SERVICE BULLETIN # 1081

MODEL 1-70

SUBJECT: CHAIN OIL LEAKAGE FROM BAR MOUNT INTERFERENCE

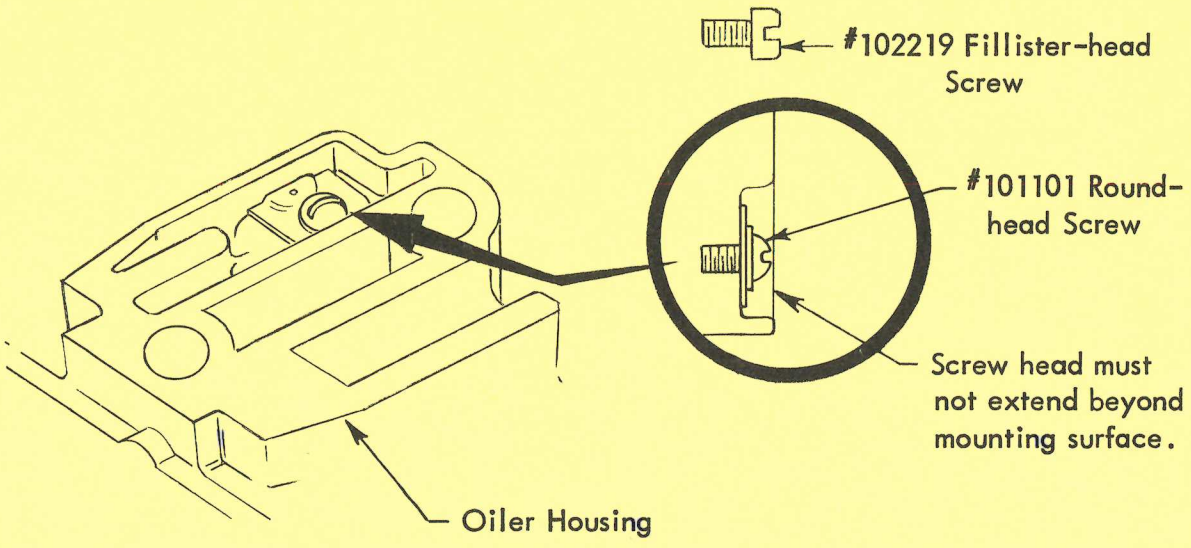
If chain oil leakage occurs between the bar and the bar mounting pad on the chain oiler housing, replace the original fillister head screw, P/N 102219, 8-32 x 1/4, with a round head screw, P/N 101101, 8-32 x 1/4.

Because of accumulated tolerances, the fillister head screw may extend beyond the surface level of the mounting pad and prevent correct mounting of the bar on the mounting pad. This will permit oil to leak between the bar and oiler housing, will prevent proper chain lubrication, and cause excessive chain wear. Replacement of the fillister head screw with the round head screw will correct the oil leakage.

NOTE: As a preventative measure, check all Model 1-70 engines and all Oiler Housing Assemblies, P/N 51938, in your stock and install the round head screw if required.
